November 30, 2020

**Re: SIR Addendum - Response to RIDEM SIR Comments  
Former Hope Mill (5 Main Street, Scituate, RI)  
RIDEM No. SR-30-0623A (Formerly Case No. 2007-010 and Part of SR-30-0623)  
ESS Project No. P312-009**

**AREAS OF CONCERN (AOCS)**

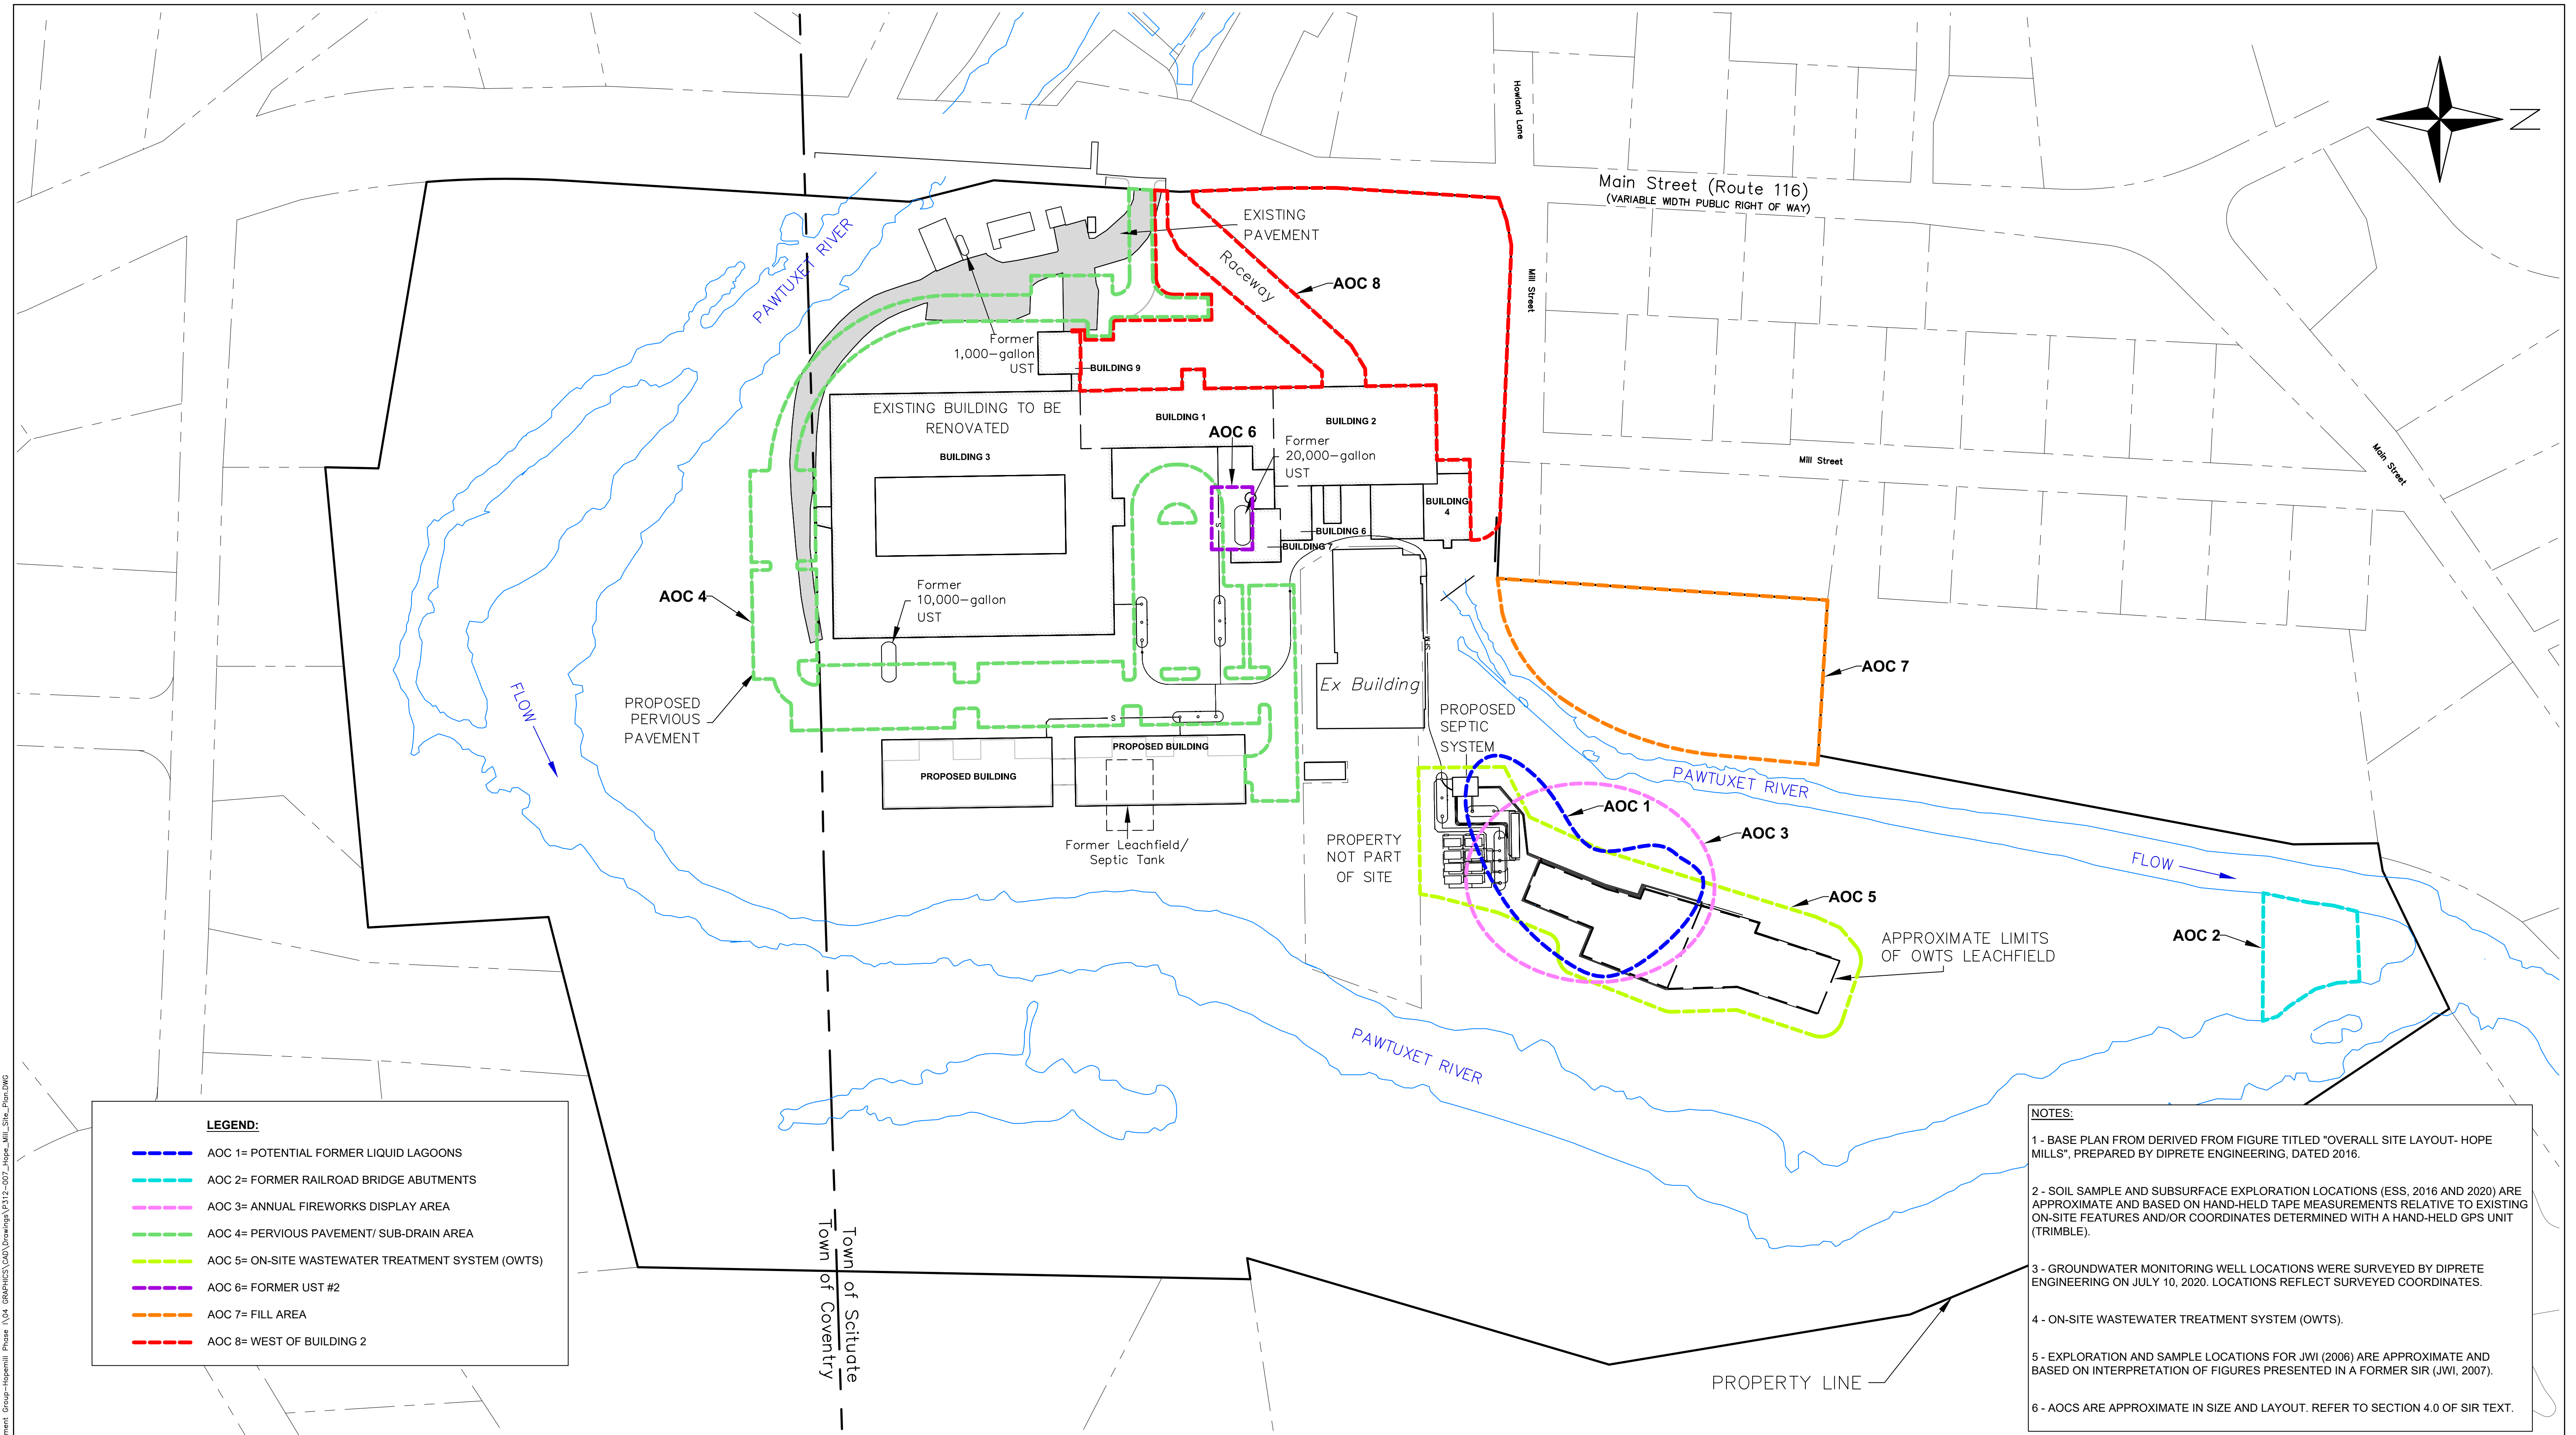
- Arsenic intermittently across the Site above the RDEC at depths ranging from ~2 to 10 feet bgs.
  - NAPL on groundwater in AOC 6 at an undetermined thickness. Note that based on PID soil screening results and observations, petroleum impacts to soil are expected from the ~4 to 10-foot depth range bgs around well MW-10 and boring ESS-63 (~10 feet away from MW-10).
9. Section 4.0 of the SIR identifies eight (8) Areas of Concern (AOCs) that were first introduced in an earlier SIR produced in 2007. Please include a Site Figure delineating the eight AOCs in the SIR Addendum.

*ESS Response:* The approximate boundaries of the eight (8) AOCs identified in ESS' SIR are now shown on a new figure (Figure 6 - Current AOC), which is attached to this submittal. It should be noted that only a portion of one AOC (AOC 6 - Former #2 UST) that was identified in the ESS SIR was introduced in the initial SIR (JWC, 2007). The remaining seven (7) AOCs were either identified based on Paramount's/BMP's proposed Site redevelopment design or the RIDEM's comments to the initial SIR (JWC – 2007). Further, except for the area identified by ESS as AOC 6 (Former #2 UST), it is the opinion of ESS that the AOCs identified by JWC in the 2007 SIR have been adequately characterized from collective SI activities.

**SOIL EXCEEDANCES IN WETLAND RESTORATION AREA**

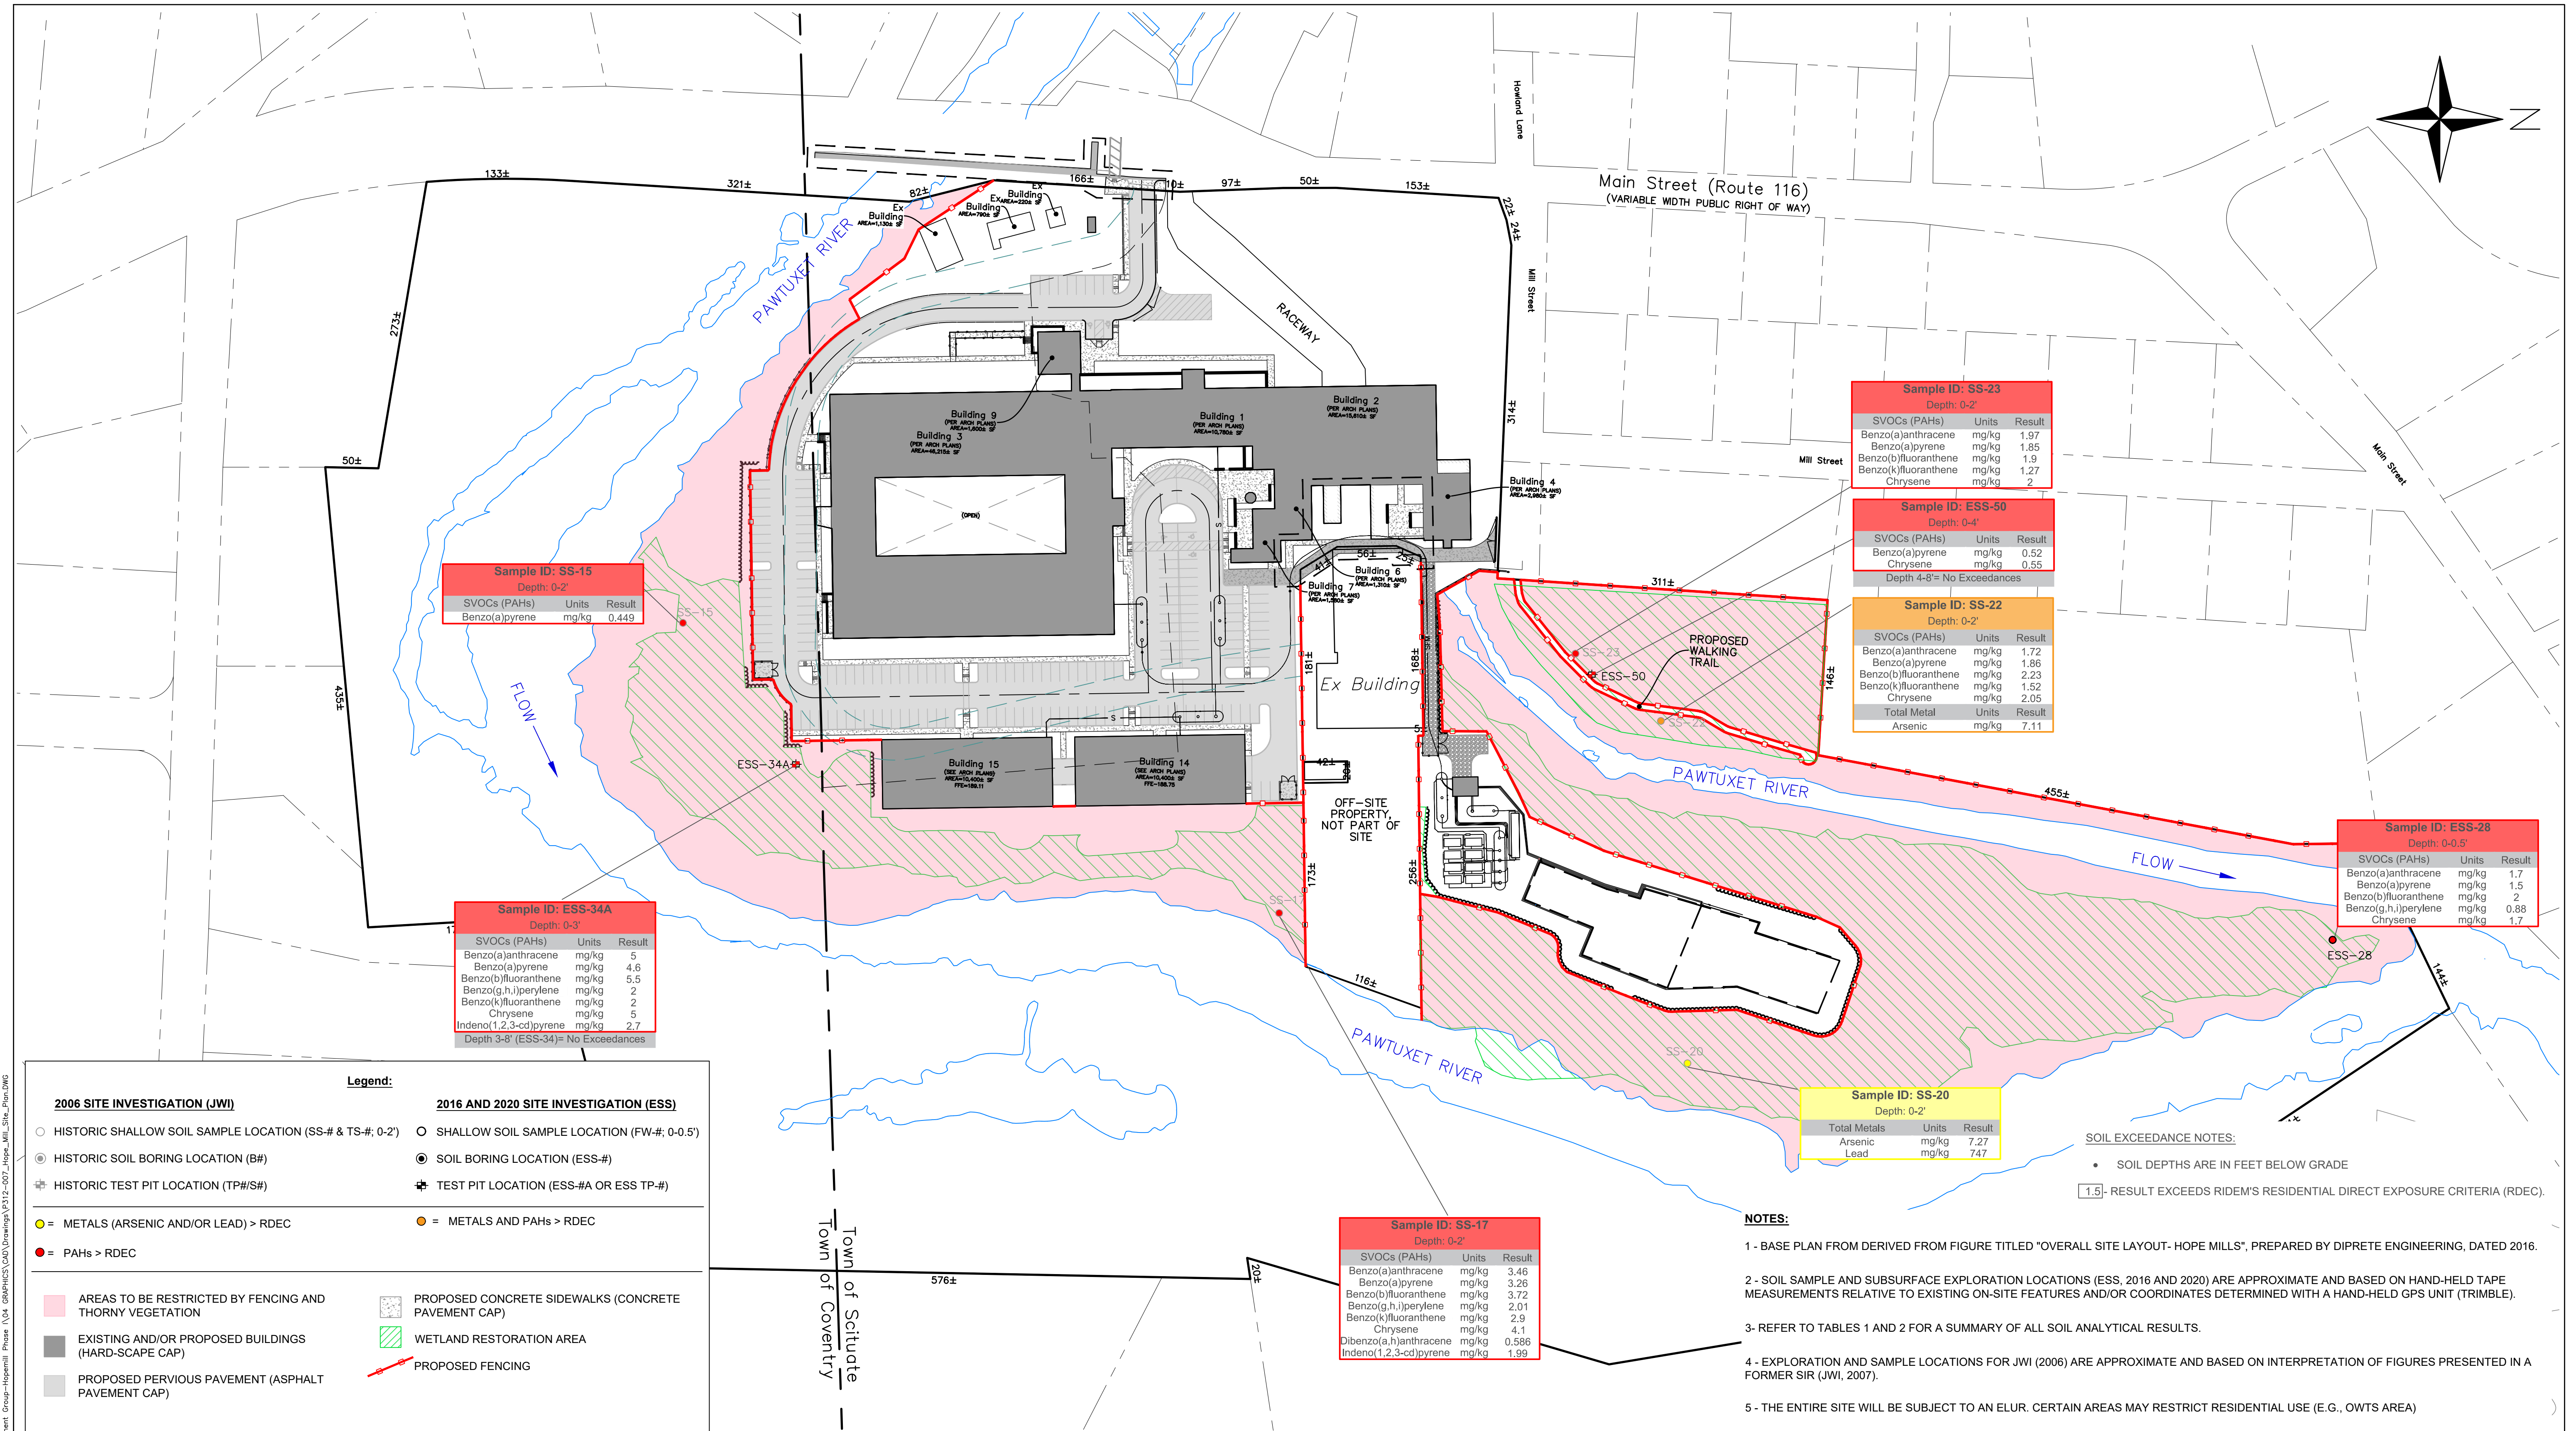
- c. Please submit a figure in the SIR Addendum, similar to the emailed draft Proposed Remedy Plan, but which also clearly shows all identified COC exceedances in areas that will be subject to wetlands restoration and are not being proposed for targeted excavation or capping activities. The Department acknowledges that many or all of these areas are proposed for installation of fencing and thorny brush to restrict or prevent future access and will be further subject to the restrictions of the ELUR.

*ESS Response: Two updated figures (Figure 8 – Soil Exceedances in Wetland Restoration Area; and Figure 8A – All Soil Samples in Wetland Restoration Area) are attached.*
